CITY OF VAUGHAN

EXTRACT FROM COUNCIL MEETING MINUTES OF FEBRUARY 22, 2023

4. BLOCK 41 BLOCK PLAN FILE BL.41.2020 VICINITY OF KIRBY ROAD TO THE NORTH, WESTON ROAD TO THE EAST, TESTON ROAD TO THE SOUTH, AND PINE VALLEY DRIVE TO THE WEST

Committee of the Whole (Public Meeting) Report

Block Plan

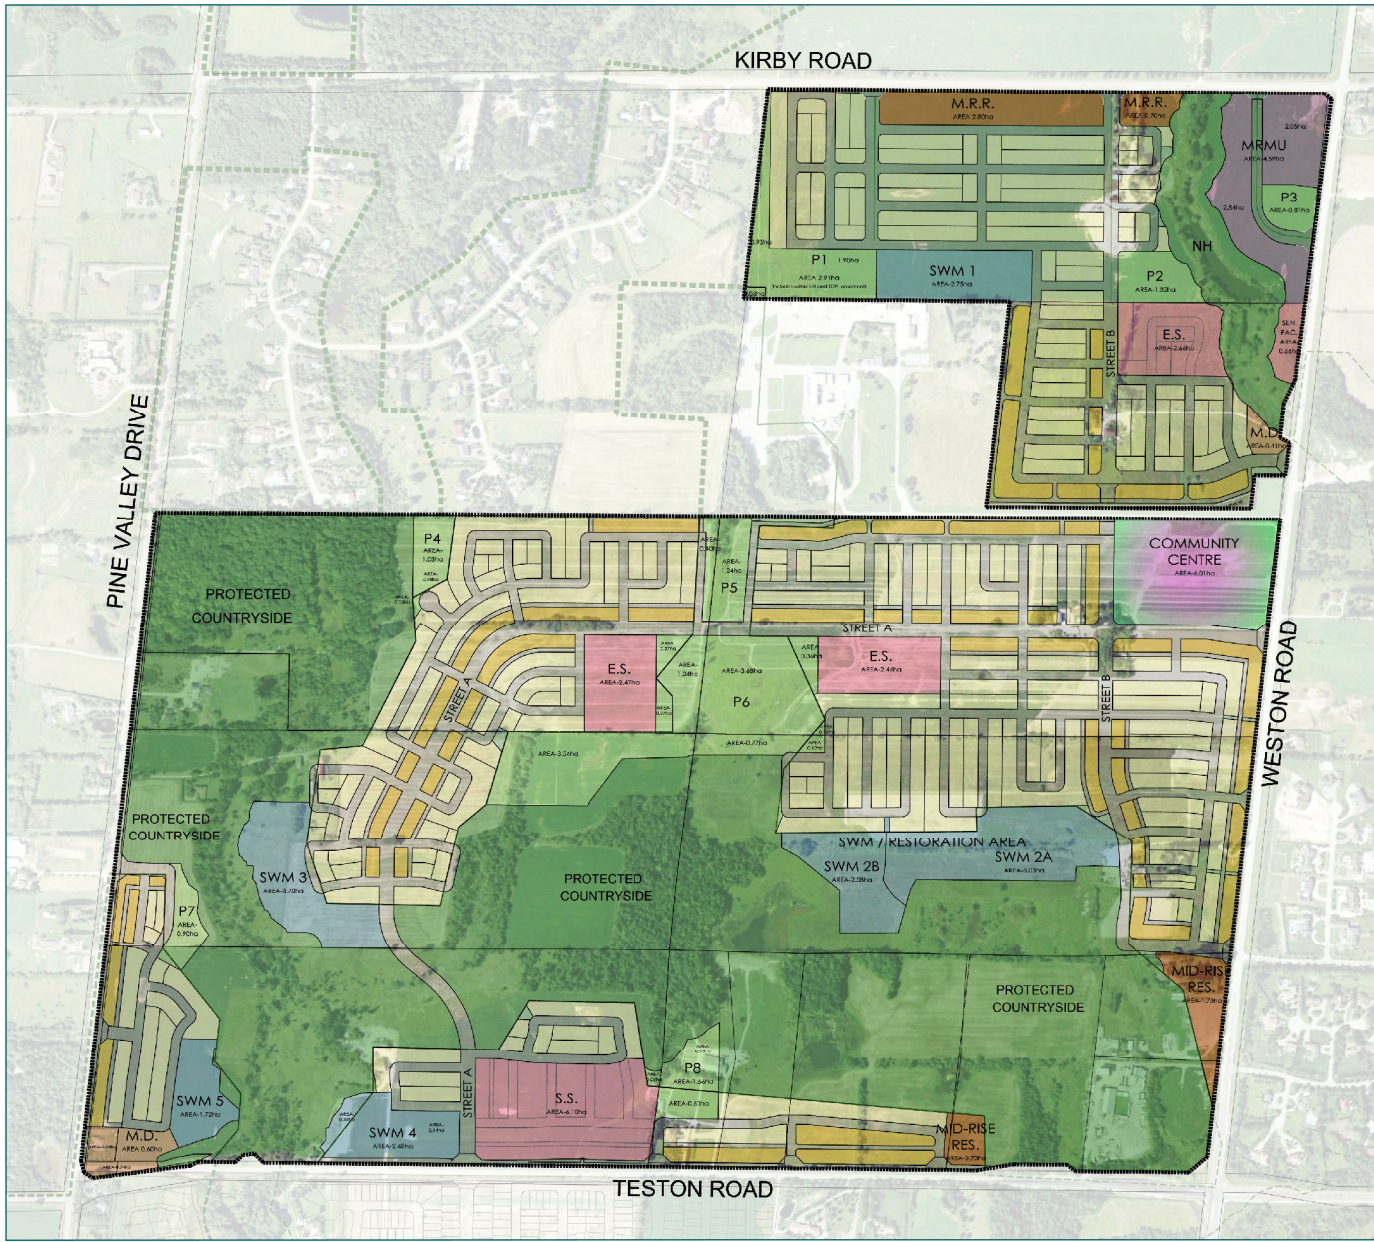
There are opportunities based on the approved Secondary Plan policies and the MZO to incorporate more retail and commercial uses into the Subject Lands. This should be explored to provide better local services to future residents. More specifically, policy 11.14.2.5 of the Secondary Plan states "A community core within reasonable walking distance from the majority of the population which will be the focus of local retail and community services and will provide connections to transit", however, the proposed location of Community Core is at the periphery of community, and contains no retail.

The policy and regulatory framework for the Subject Lands permits a wide variety of land use designations and building typologies. Consideration should be given to providing a greater variety of development typologies and uses in the low-rise mixed use and mid-rise mixed use designations to bring the Block Plan into better alignment with the vision established by the Secondary Plan.

Furthermore, per policy 6.6.3 of the Secondary Plan, parkland is not permitted within the setbacks to the pipeline right-of-way; this may impact Park P5 and the co-location facility, as shown on Attachment 3.

It has been identified by internal City departments, as well as external agencies, that portions of the proposed internal road network abutting and/or encroach into the Protected Countryside designation of the Greenbelt Plan, which is not consistent with Section 4.2 of the Greenbelt Plan.

Per policy 3.2.3.4 of VOP 2010, natural heritage features within the Greenbelt require a 30 m vegetation protection zone ('VPZ'). The material submitted in support of the Block Plan application do not follow the minimum VPZ requirements, as several encroachments into the VPZ have been identified within the Greenbelt Plan Area. Residential development and park features must be removed from natural heritage features and their associated VPZs on the Greenbelt.

The Block Plan application proposes three (3) elementary school sites, and one (1) secondary school site, as shown on Attachment 3. Two (2) of the elementary school sites and the secondary school site have been identified for the York Catholic District School Board ('YCDSB'), and the remaining elementary school site for the York Region District School Board ('YRDSB').

YRDSB have advised they are generally satisfied with the location and size of the proposed elementary school site, but have concerns respecting its configuration. YRDSB requires a minimum depth of 125 m to facilitate the development of their elementary school model, however, the maximum depth provided for the school block is 105.9 m. YRDSB is requesting that the applicants revise the school block to have a minimum depth of 125 m, or alternatively, provide a facility fit plan which demonstrates that a typical elementary school can be accommodated on the current configuration which meets the needs of the YRDSB.

Per policy 6.1.2(2) of the Secondary Plan, “reverse frontages should be avoided”. The co-location facility is surrounded by the rear of townhouse units, which is not a desirable interface, and where alternatives should be considered.

The proposed location of the secondary school block, located along Teston Road, and abutting “Low Medium Density (Lane Access)” development is not a desirable interface, and should be revised to allow for better integration with the rest of the community.

Five (5) of the eight (8) parks proposed as part of the Block Plan application are located within the Greenbelt Plan Area (being parks P4, P5, P6, P7 and P8 as shown on Attachment 3). It is understood that proposed parkland within the Greenbelt Plan Area, can be facilitated by MMAH's approval of the YROP 2021, subject to additional criteria; however, confirmation is required in this regard. In addition, the City is seeking that the applicant provide a rationale as to how the Greenbelt Plan provisions will be met, ensuring the proposed parks are able to be programmed with recreational uses such as sports fields and courts, play equipment, and other facilities under the "Rural" redesignation of the Greenbelt Plan.

While it is understood that active parkland on the Greenbelt is permitted by MMAH's approval of the YROP 2021, the proposed parks should not be subject to restrictions that prohibit public recreational programming. Four (4) of the five (5) parks that are proposed within the Greenbelt Plan Area are encumbered by natural heritage features, including wetlands, woodlands, natural hazards and their associated VPZs. These encumbrances will restrict park programming. In accordance with Sections 3.3.2, 3.3.3, and 4.1.2 of the Greenbelt Plan, where parks are proposed within the Greenbelt Plan Area, they must be located outside key natural heritage features and key hydrogeological features and their associated VPZs, and also outside prime agricultural areas.
